Addendum No.: 1

Date Of Addendum: 01/03/2019

New Storage Garage  
Henry Abbott Technical High School  
Danbury, CT  
BI – RT – 888

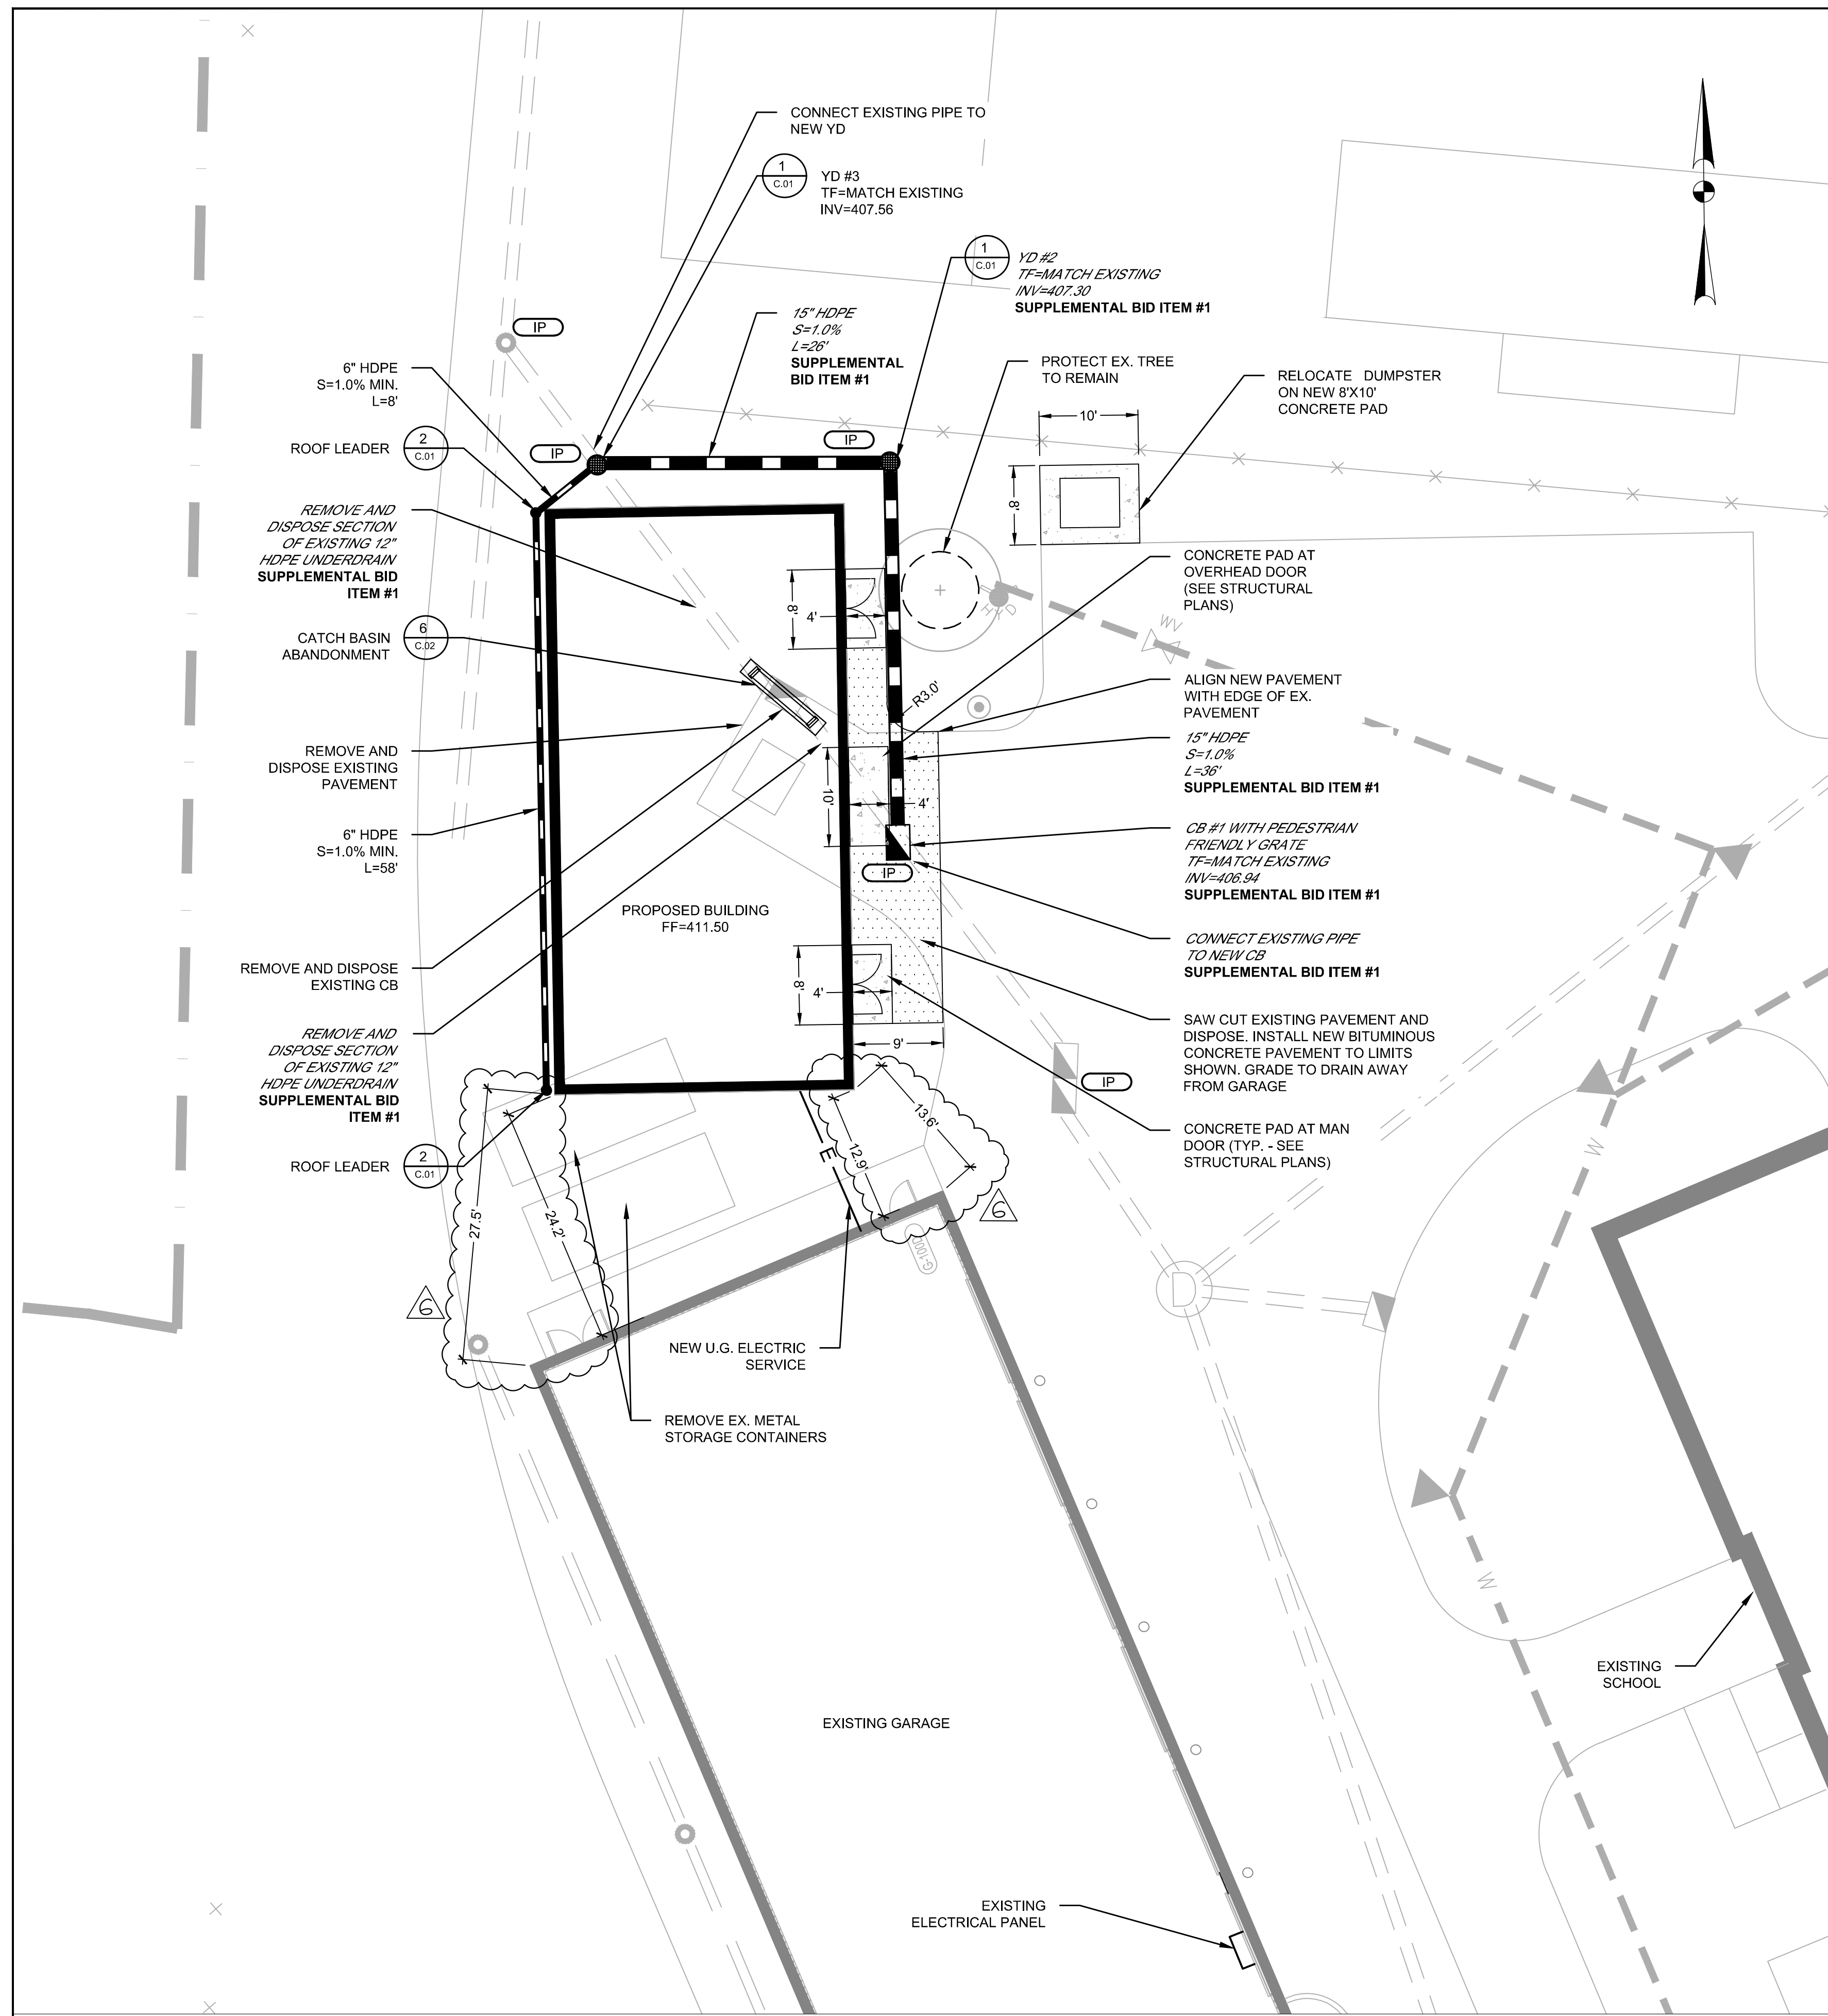
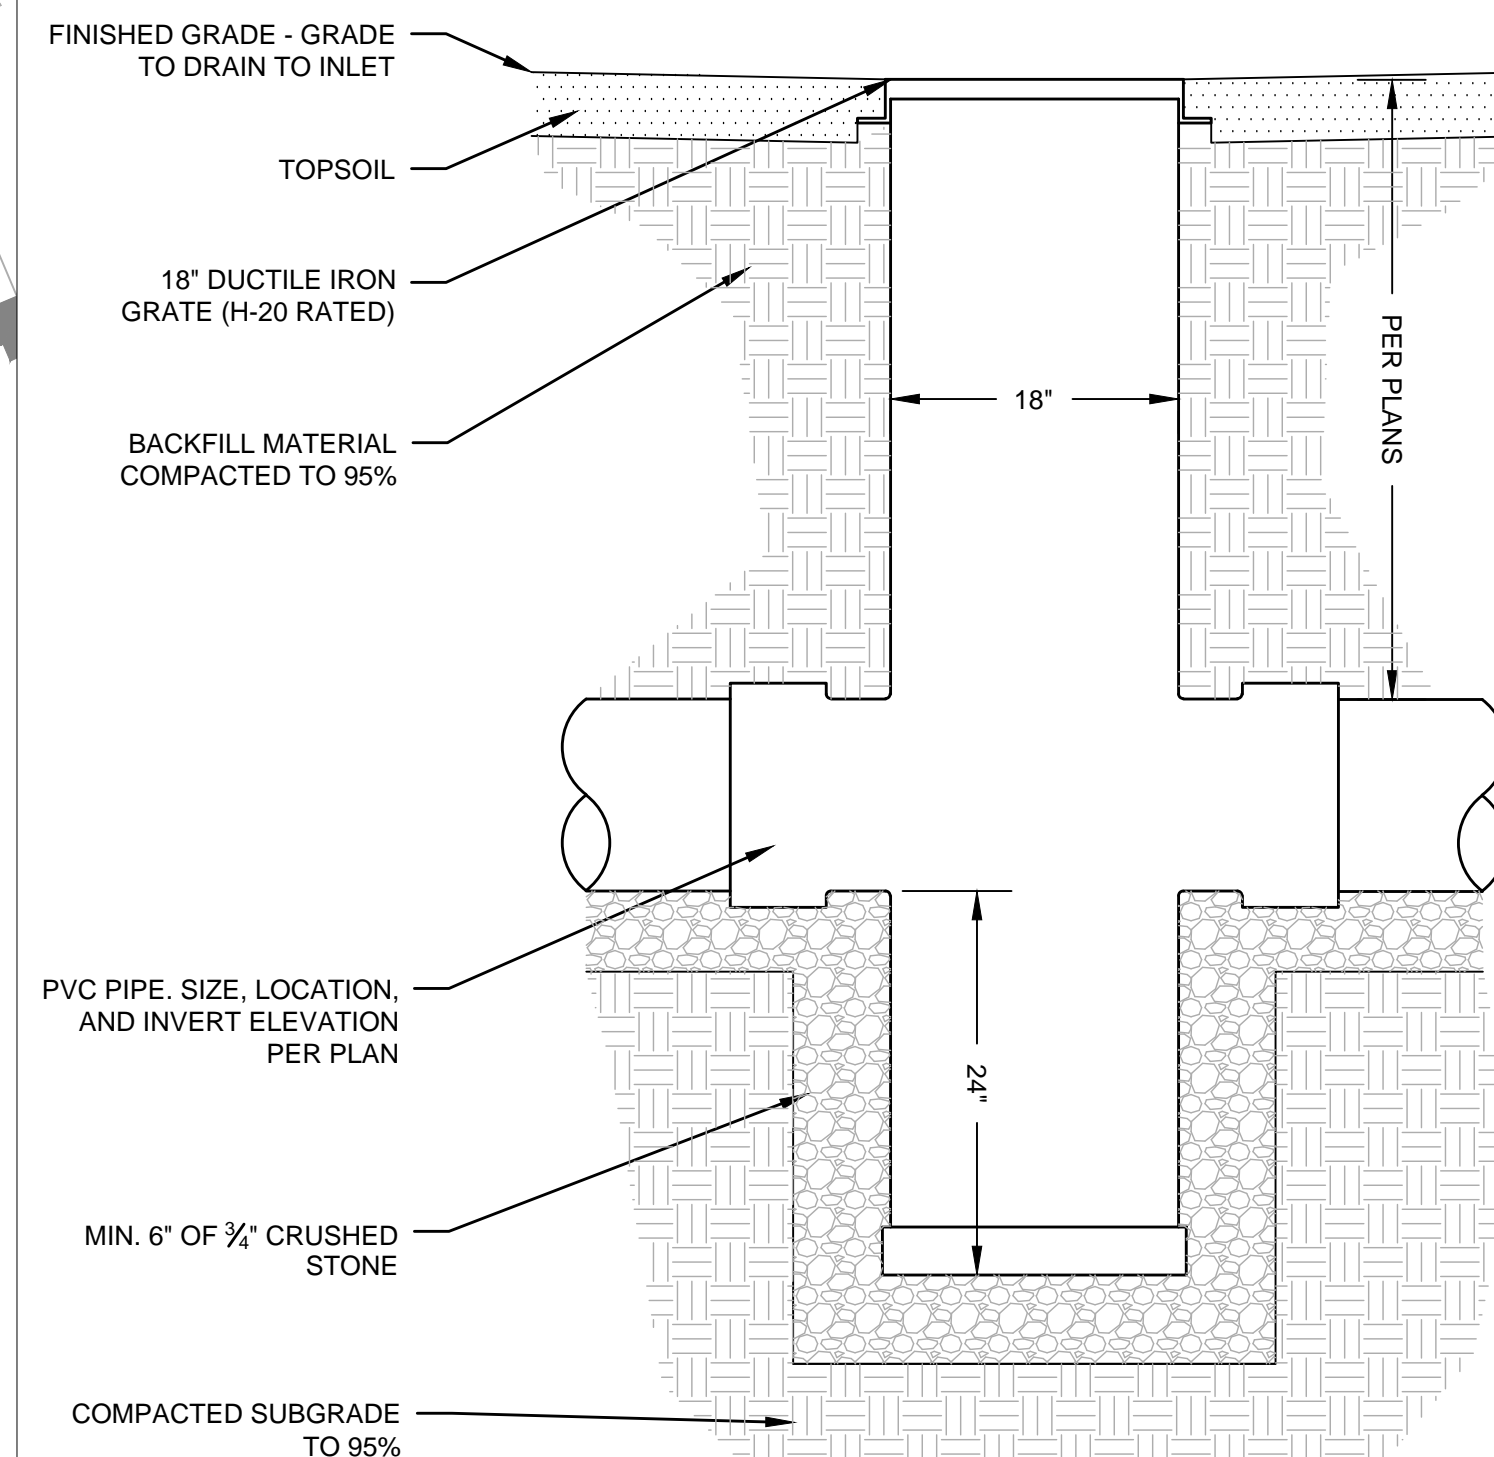
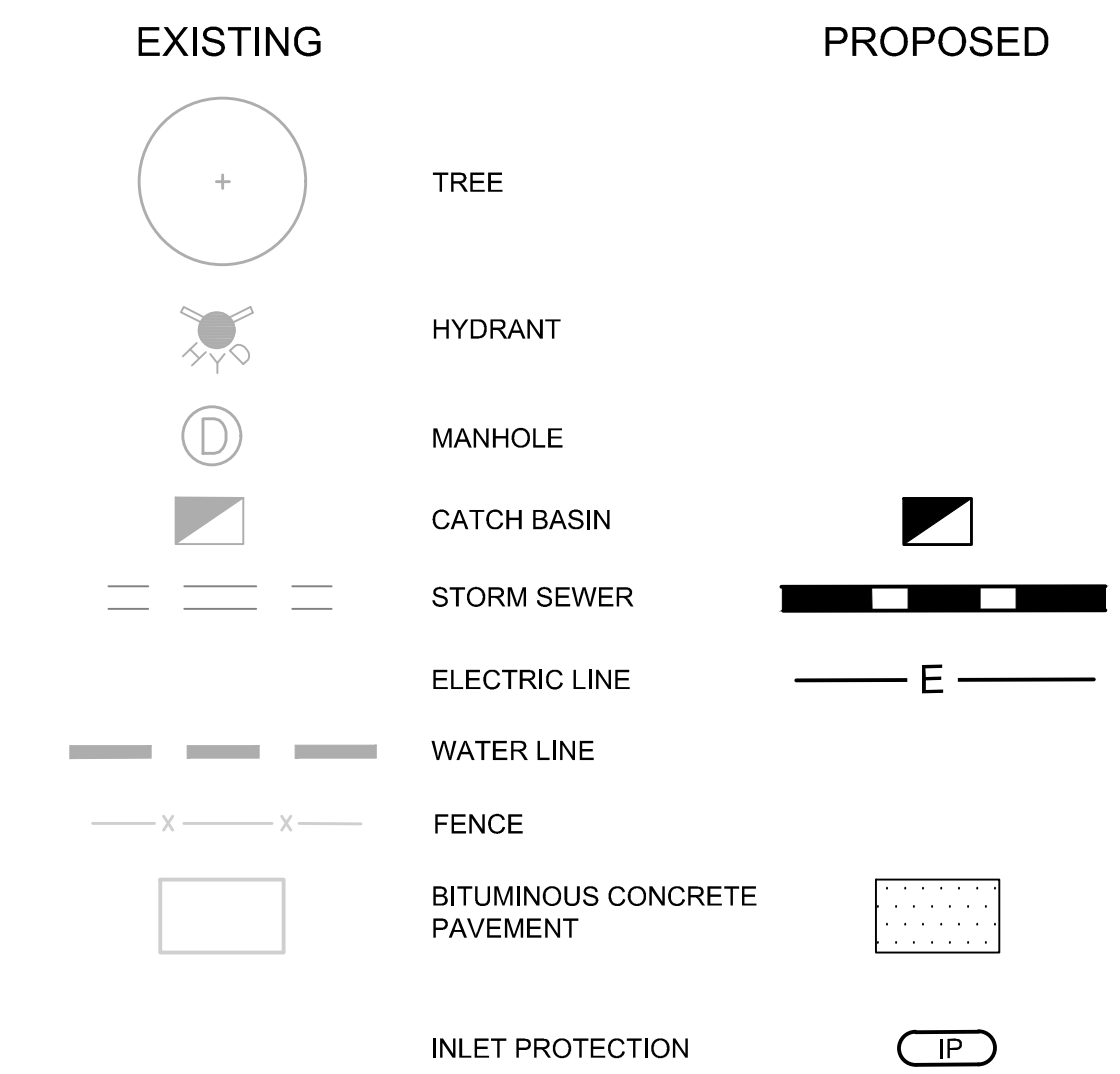
Replace Plan Drawing C.01 with attached revised (12/18/18) Plan Drawing C.01 which adds dimensions to locate proposed building on the site in reference to existing garage building adjacent to it.
